**APPENDIX 4B**

**DETAILED DRAWINGS FOR THE 200 AREA EFFLUENT TREATMENT FACILITY  
CONTAINER STORAGE AREA AND TANK SYSTEMS**

1. ECN 647892

H-2-89036, SH 1

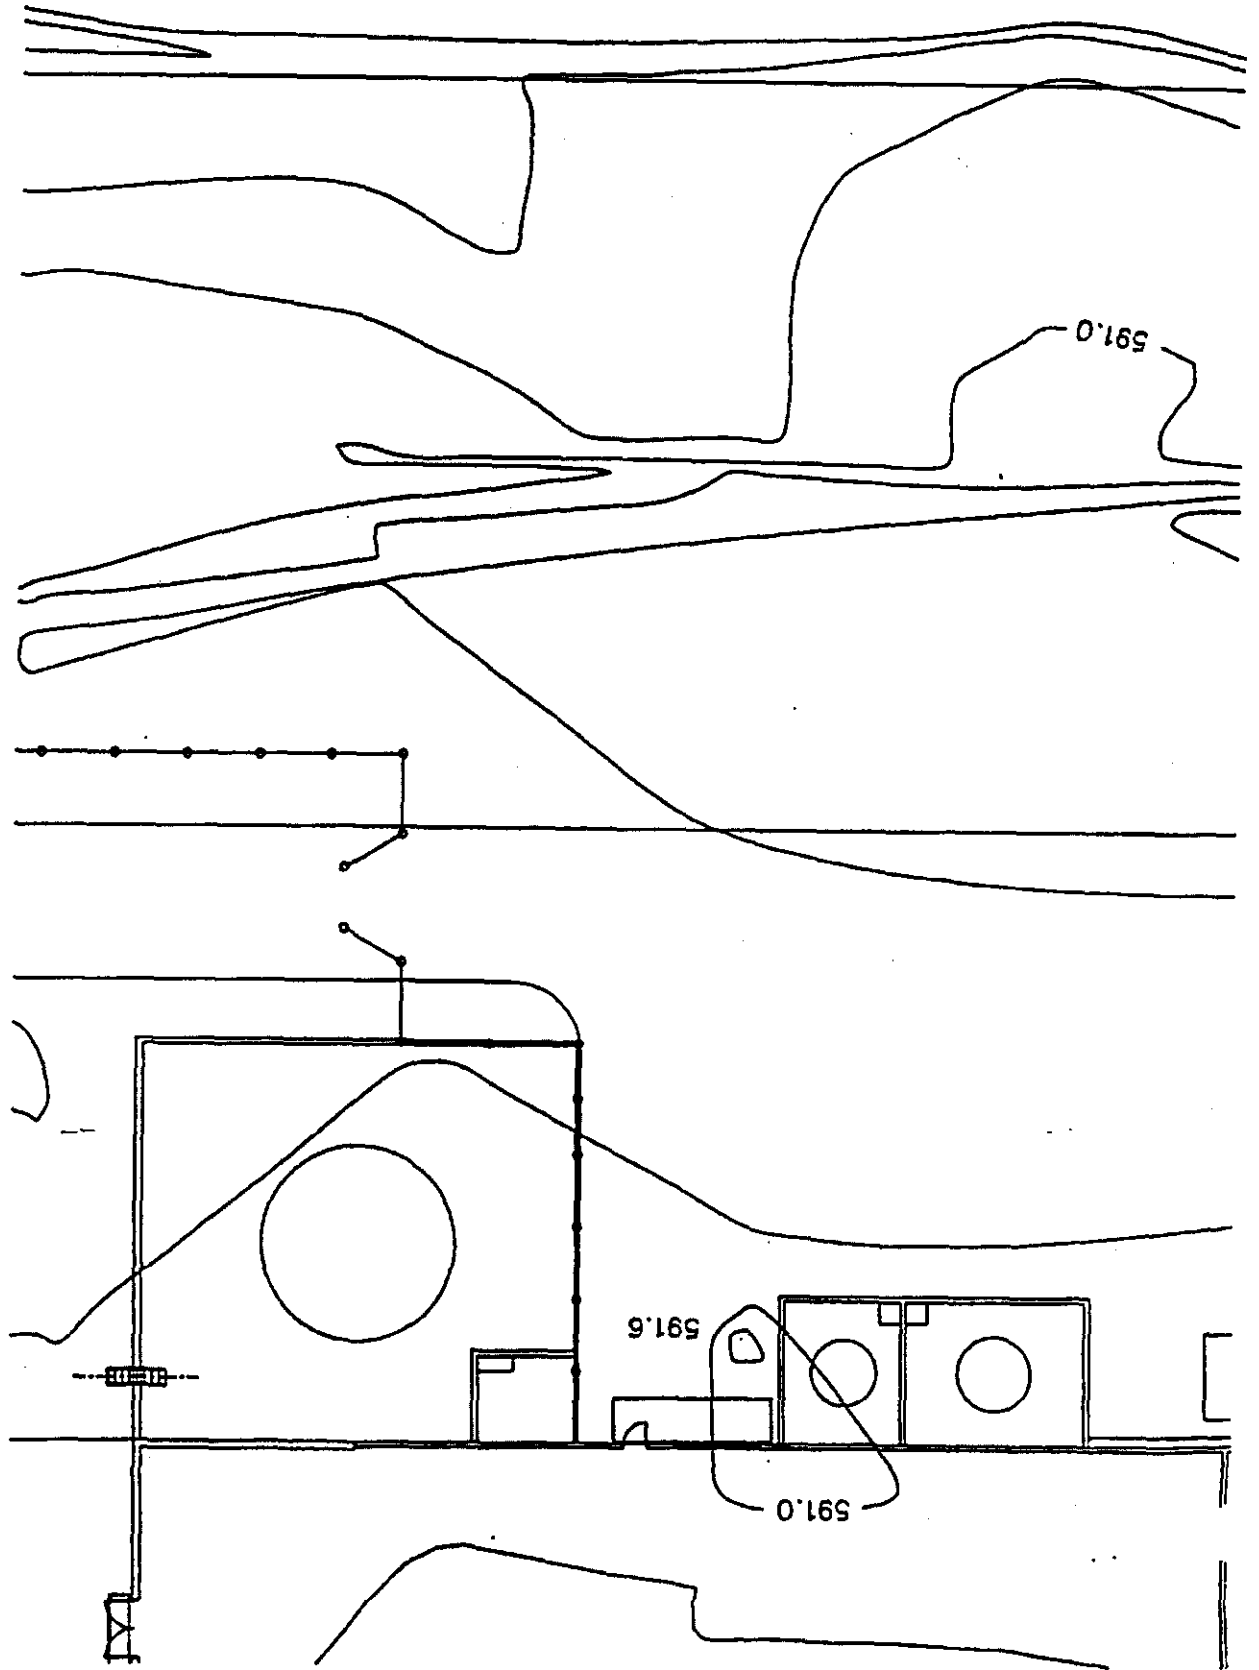
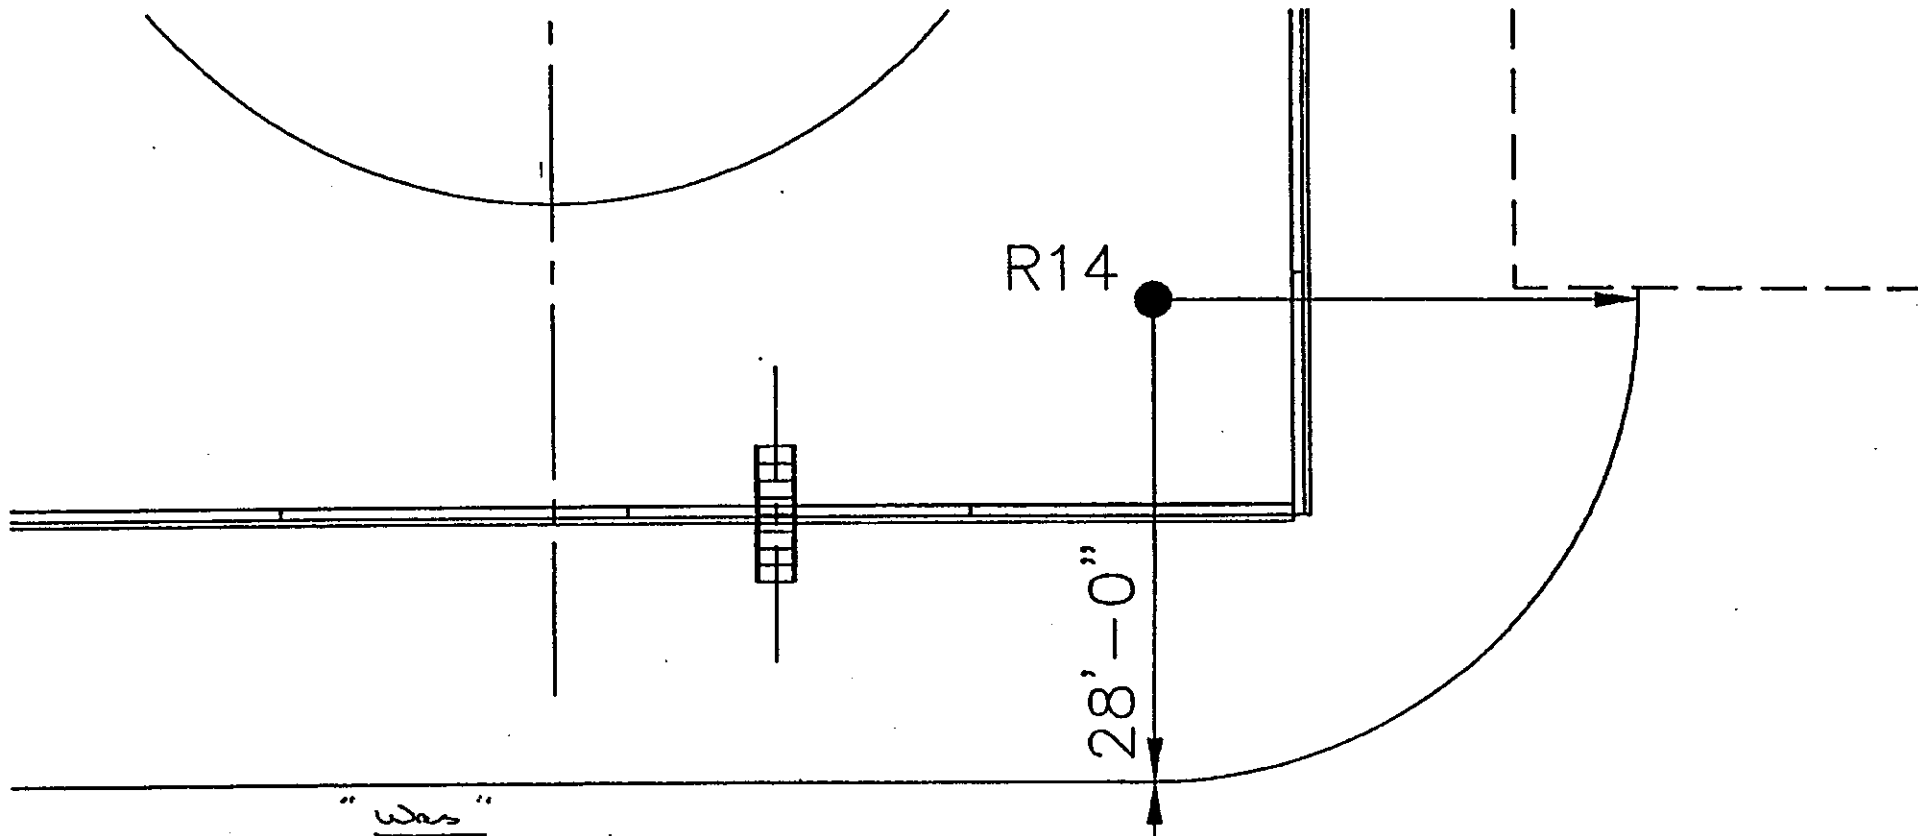
- H-2-89033, Sh 1, Zone D-3: Replace ladder with stairway.
- H-2-89036, Sh 1, Zone E-4: Replace ladder with stairway.
- H-2-89039, Sh 1, Zone B-4: Replace ladder with stairway & show new sidewalk.  
Zone E-4: Replace ladder with stairway.
